**FINAL**  
**SEAD-11, SEAD-64A, SEAD-64D**  
**PROJECT SCOPING PLAN FOR PERFORMING A**  
**CERCLA REMEDIAL INVESTIGATION/FEASIBILITY**  
**STUDY (RI/FS) AT THE CONSTRUCTION DEBRIS**  
**LANDFILL (SEAD-11) GARBAGE DISPOSAL AREAS**  
**(SEAD-64A AND SEAD-64D)**

**PROJECT SCOPING PLAN  
REMEDIAL INVESTIGATION/FEASIBILITY STUDY  
AT SEAD-11, SEAD-64A, & SEAD-64D  
SENECA ARMY DEPOT ACTIVITY  
ROMULUS, NEW YORK**

**Parsons Engineering Science, Inc.  
Prudential Center  
Boston, Massachusetts**

FIGURE 4-5  
**PROPOSED SAMPLING LOCATIONS**

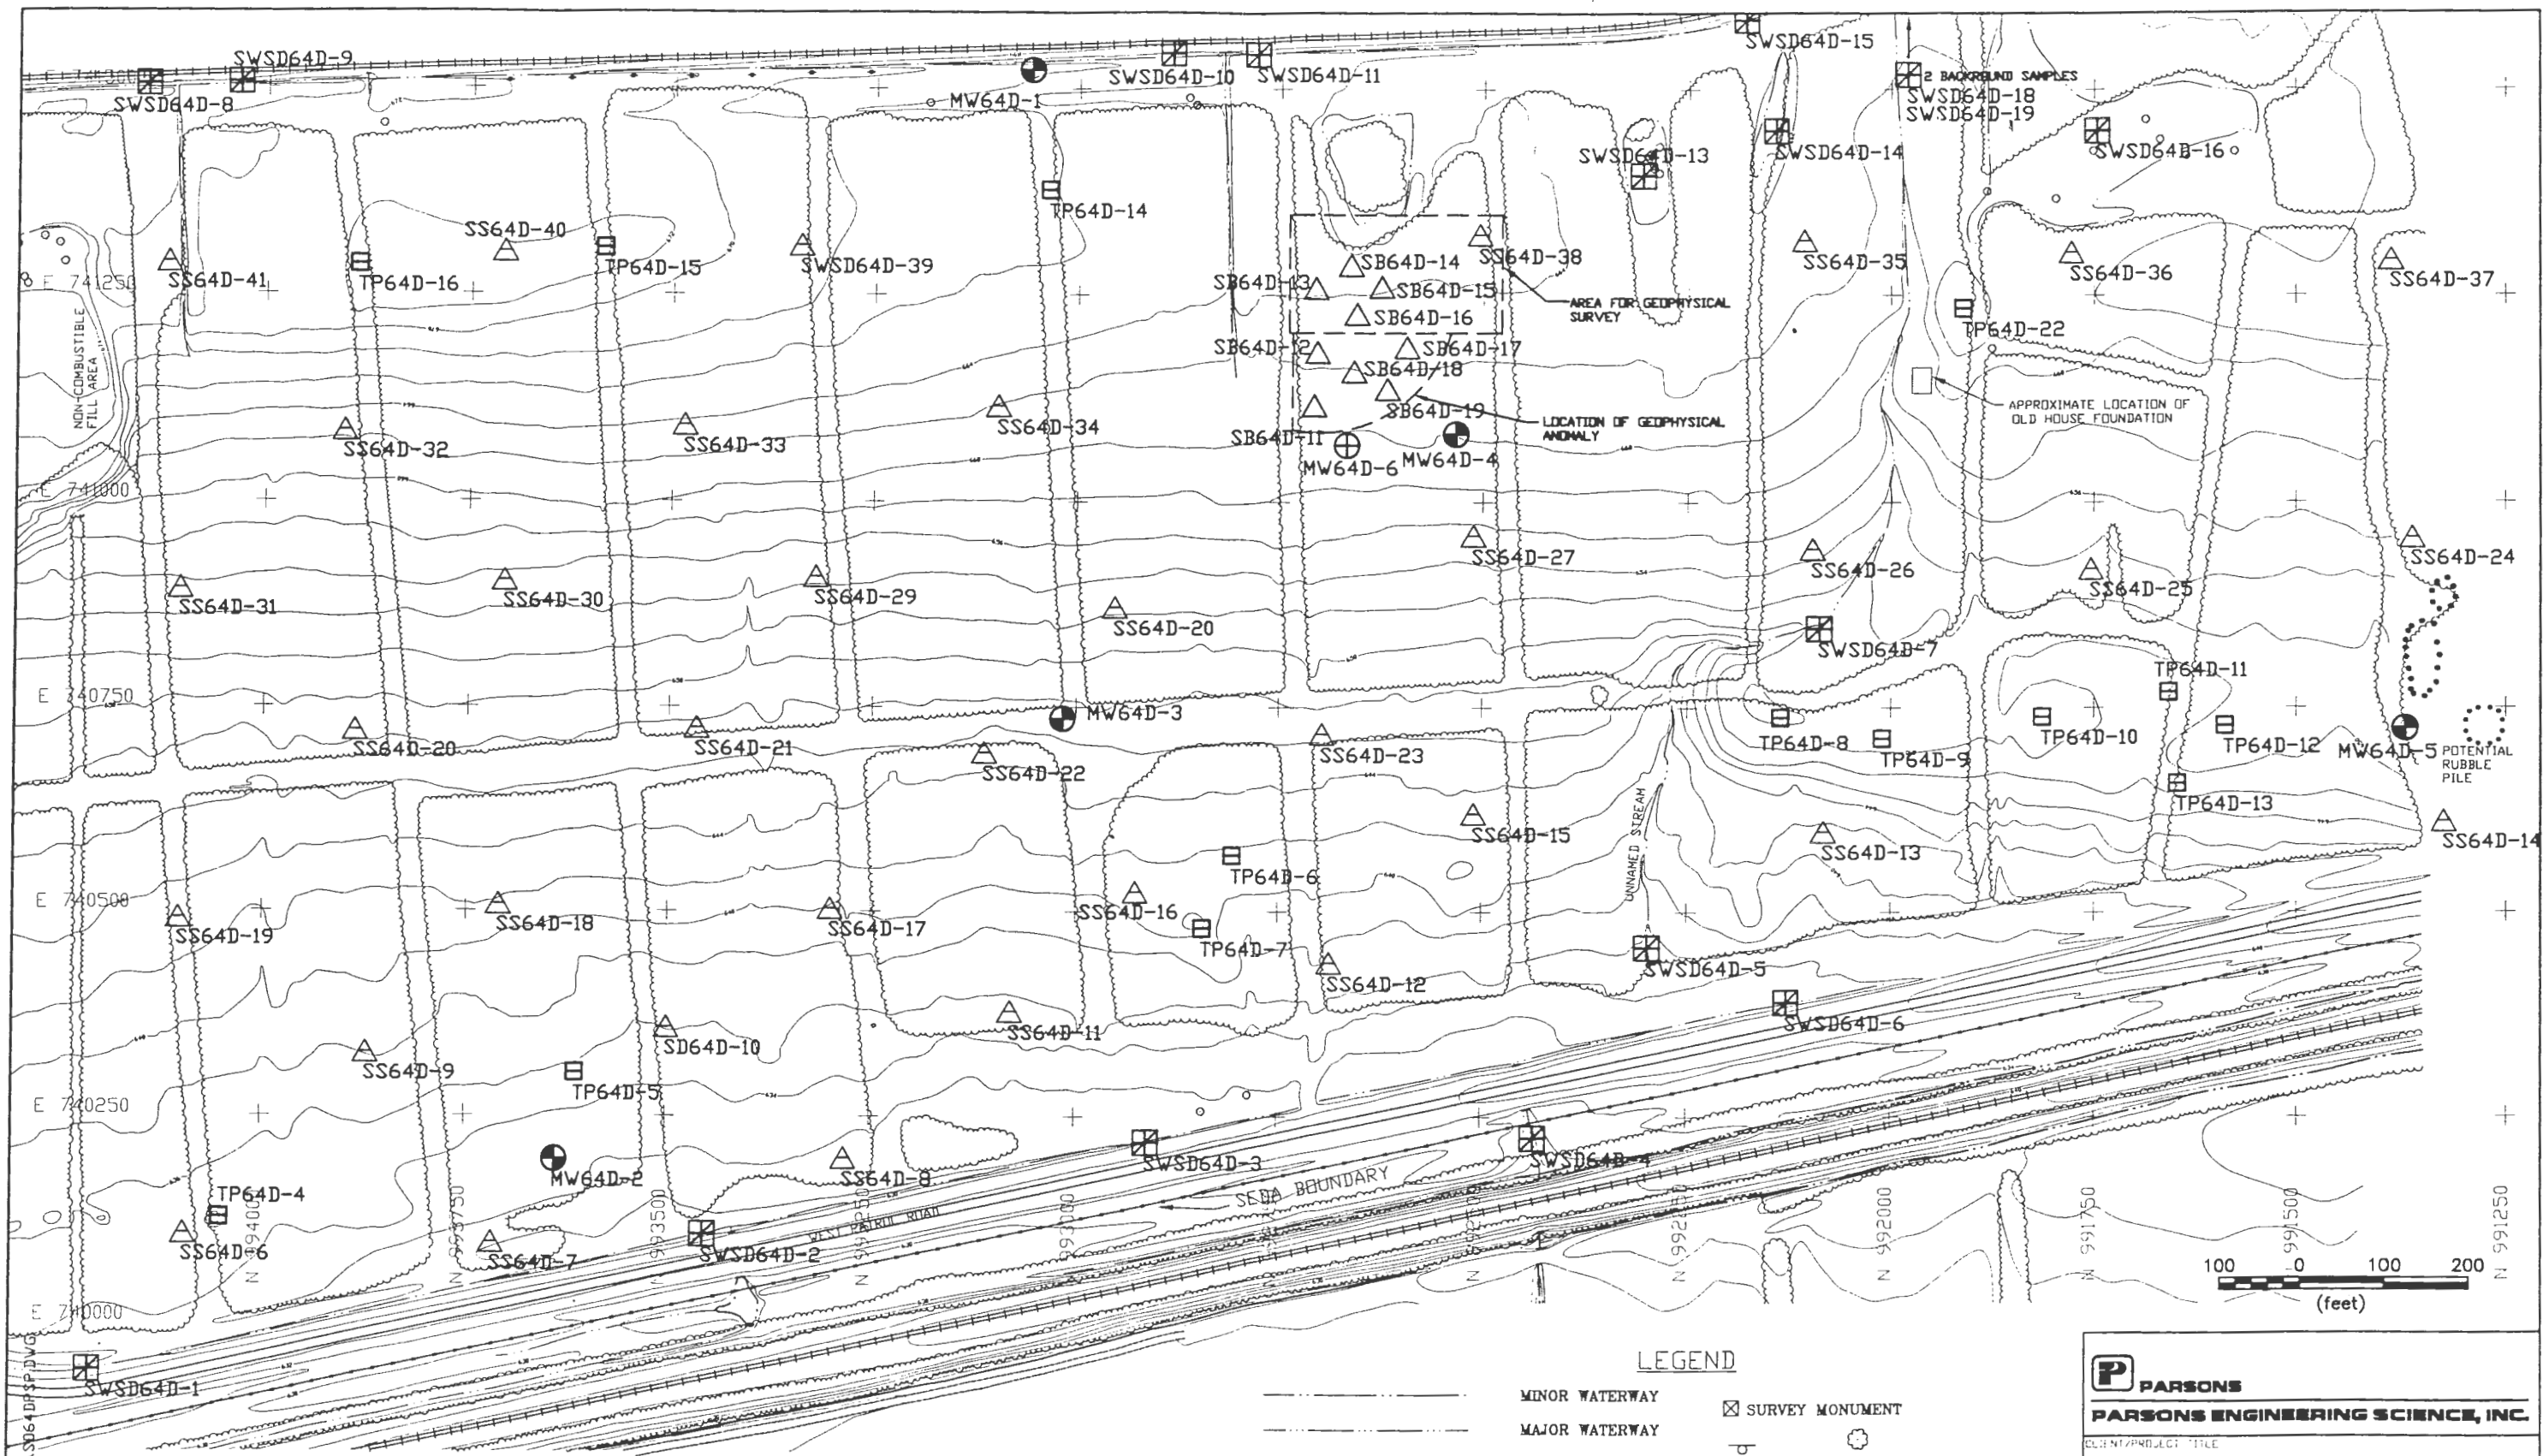
- Comment #13** Section 4.4.1. Geophysical Survey. The Figure referenced in this section (Figure 4-1) does not present the area of the electromagnetic survey.

- Comment #19** Section 4.4.3.1. The location of wells MW64D-2,3, and 4 are not shown on either Figure 4-5 or 4-6. These should be presented for each reference.

- A map showing the location of proposed EM-survey lines should be presented to aid in the evaluation of the survey.
- Response #13** Acknowledged. Figure 4-5 shows the area for geophysical survey at SEAD -64D. The EM transect lines will be established using grid and profile-based surveys. The grid based surveys will use either a 10x10' or 20x20' grid spacing. The corners of the grids will be established using a registered NY State land surveyor. The individual EM-31 survey lines and station locations will be established using hip chains and hand held compasses.

- The reference to Figure 4-1 has been corrected to Figure 4-5.
- Comment #14** Page 4-30, p2. The sampling depths provided assume the depth to bedrock is uniform across the area to be investigated. The text should describe at what depth samples will be collected if the depth to bedrock is greater than anticipated.

then, the five new wells will be installed in the locations shown in Figures 4-5 and 4-6. All newly installed and existing wells will be sampled twice. The text has been revised to reflect this.
